UNITED STATES ENVIRONMENTAL PROTECTION AGENCY
REGION III
1650 Arch Street
Philadelphia, Pennsylvania 19103-2029

Re: W.Va. Code §22-11-7b(f) Assessment Methodology for the Biological Component of the
      Narrative Criteria in Wadeable Streams

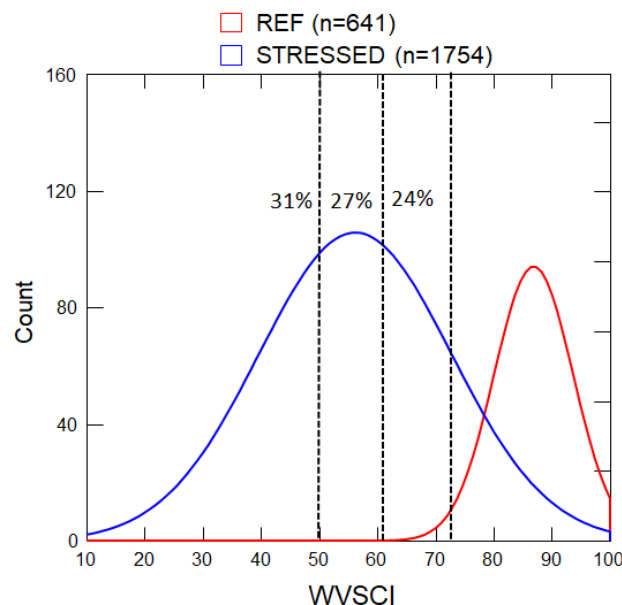
- No justification on threshold derivations has been provided for this proposed rule. The selected thresholds do not appear to be based upon standard derivation methods and appear likely to result in numerous instances of "false negatives" (failure to detect impairment). EPA used WVDEP data (n=7650) to calculate what proportion of samples collected in locations considered to be stressed (n=1724) fell within each category of WVDEP's proposed rule. EPA found that with the proposed thresholds, only 31% of known stressed sites (n=551 out of 1724) would automatically be deemed impaired (WVSCI <50); 27% (n=469 out of 1724) would require additional stressor identification or a second biological sample (WVSCI 50-61); and 24% (n=441 out of 1724) would be placed into a scoring threshold range requiring a second biological sample (WVSCI 62-72) (see WVSCI distributions between reference and stressed sites in the figure below). Based on this information, EPA recommends that samples with a WVSCI score less than the attainment threshold (72, as proposed) should automatically be considered impaired (for further discussion on this point, see comments on "Second Sample Requirement", below).

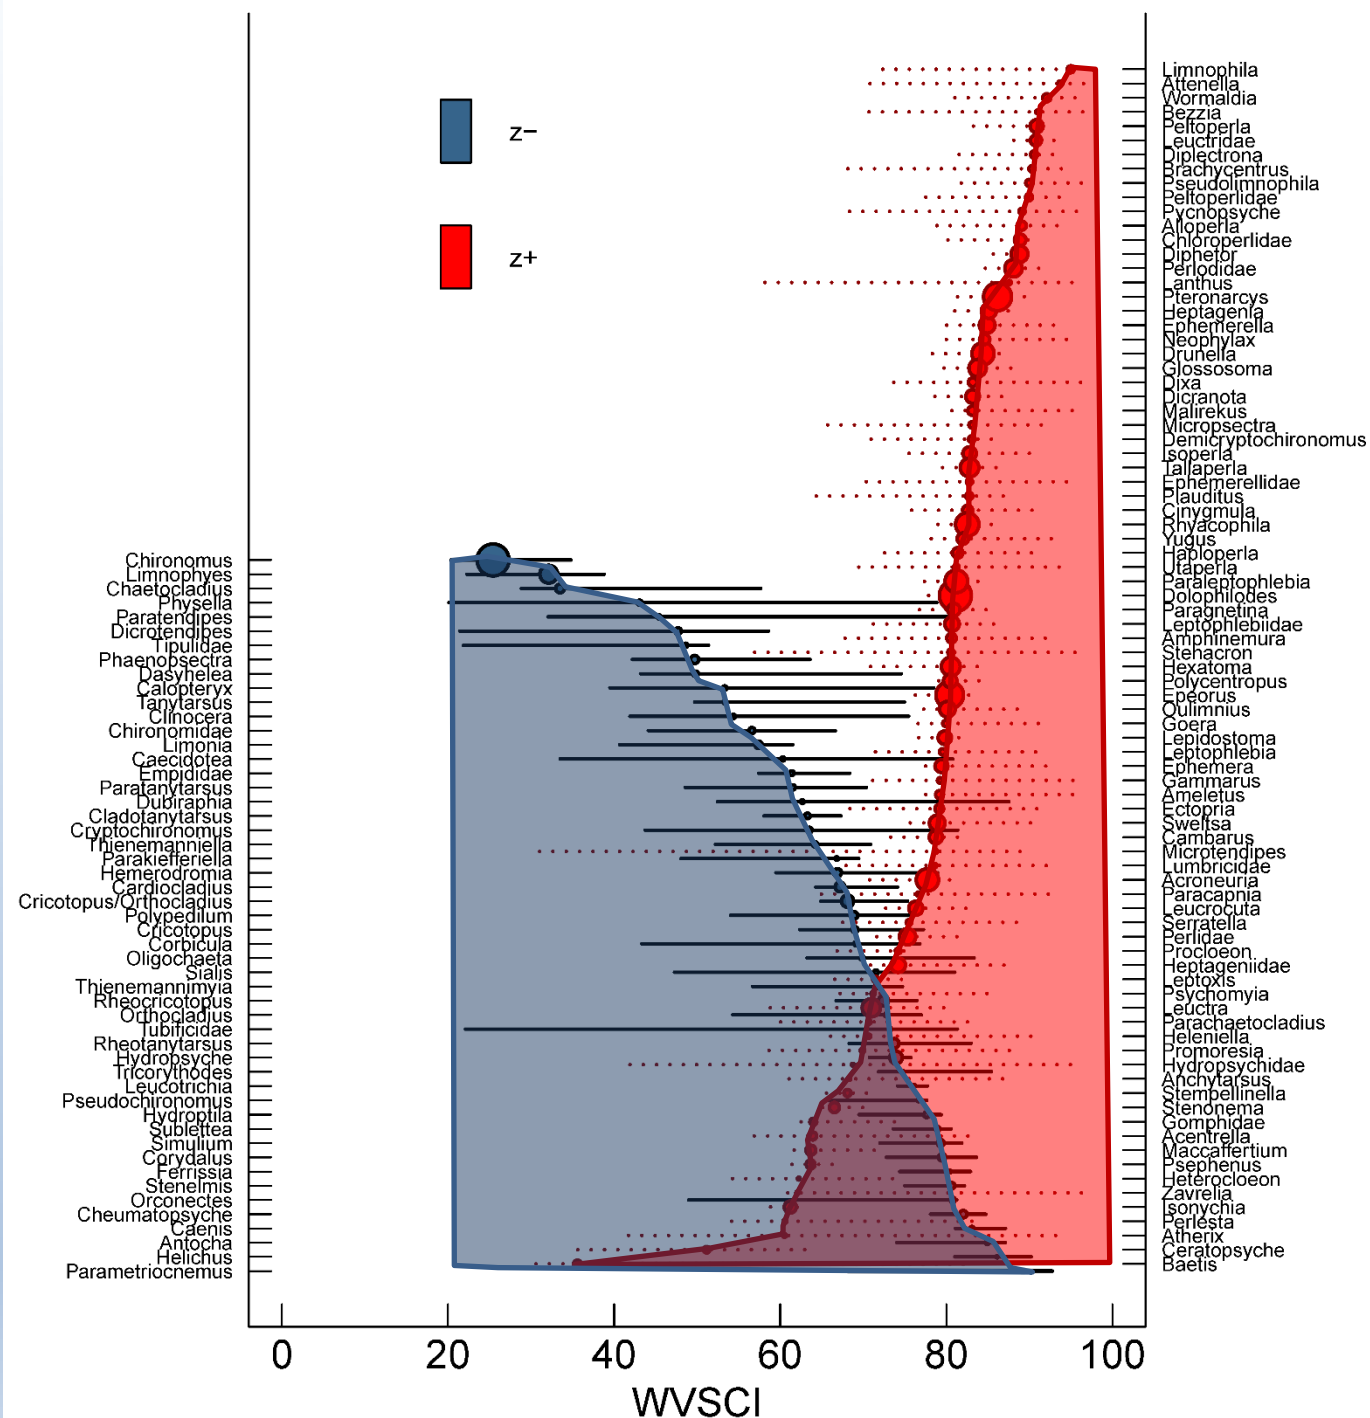
136 of 185 genera/OTUs were pure & reliable indicators (74%)

77% of sensitive taxa (85) declined @ WVSCI 80-95

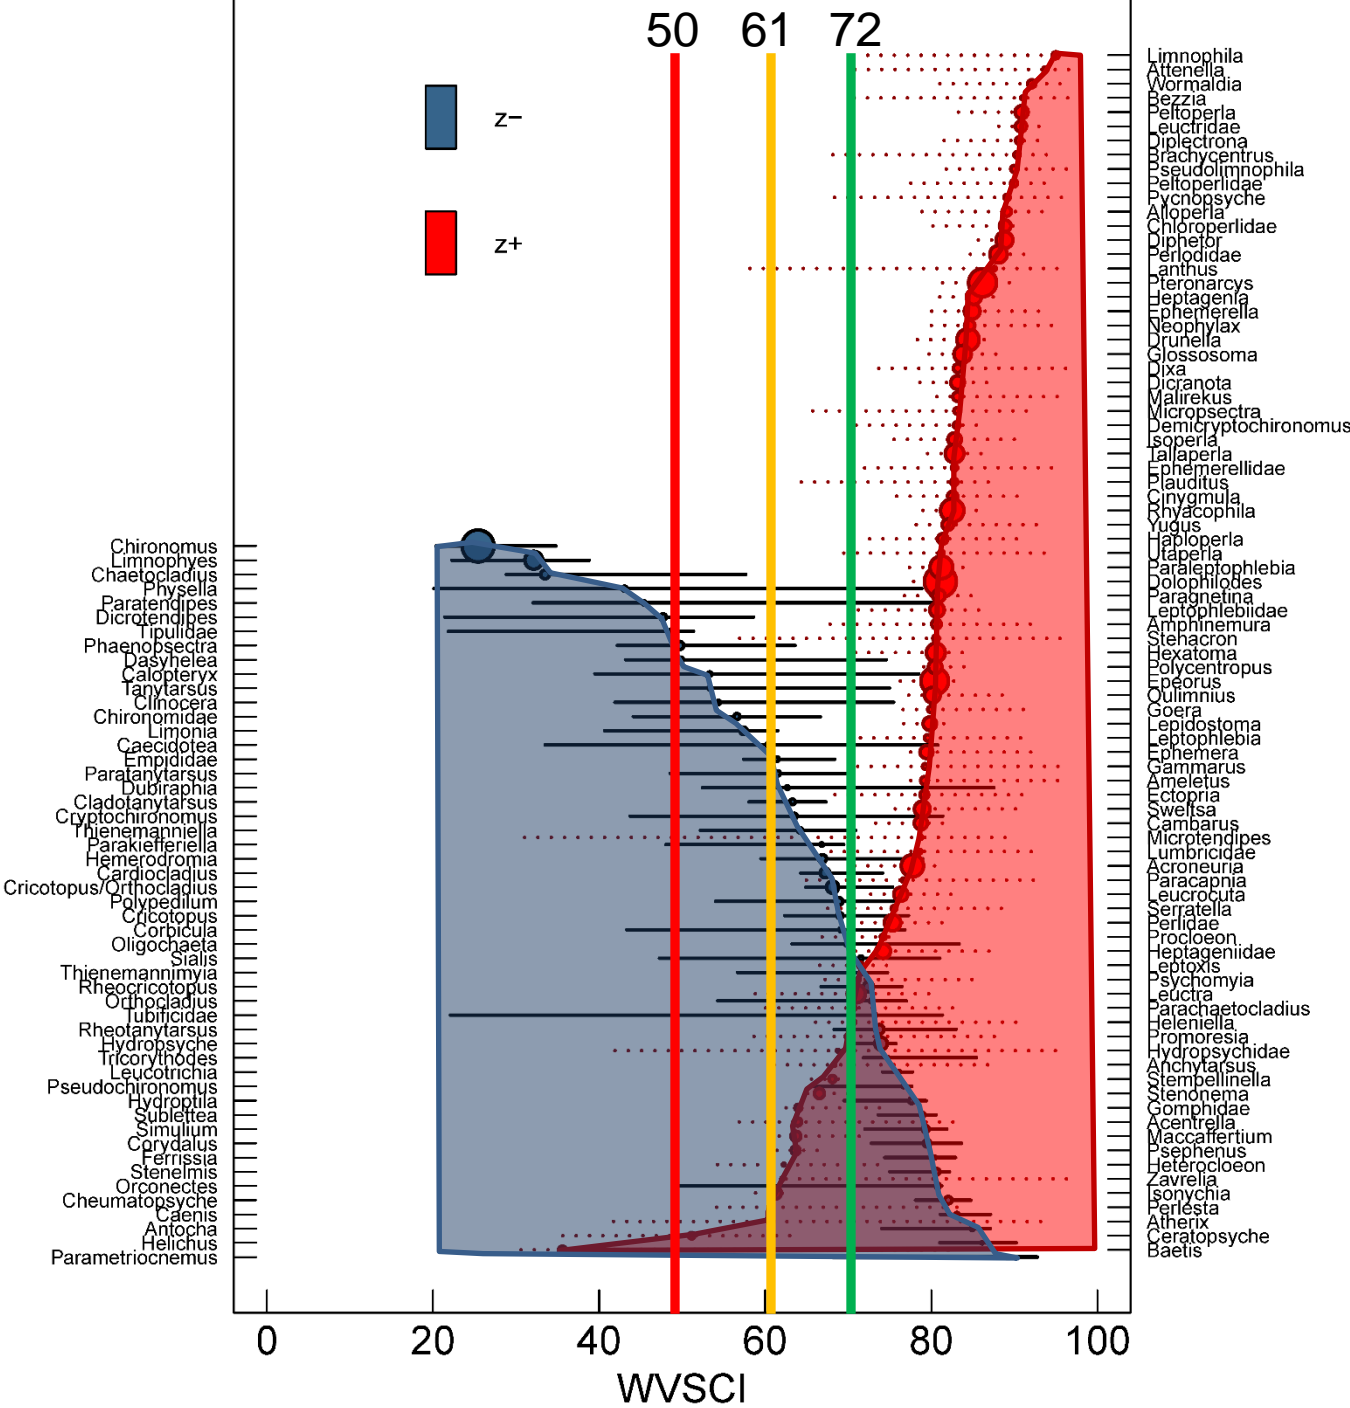
Attainment threshold (72) falls below 80% of sensitive taxa change points

"Impairment (maybe)" threshold (61) falls below virtually all sensitive taxa

"Definitely impaired" threshold (50) is definitely impaired
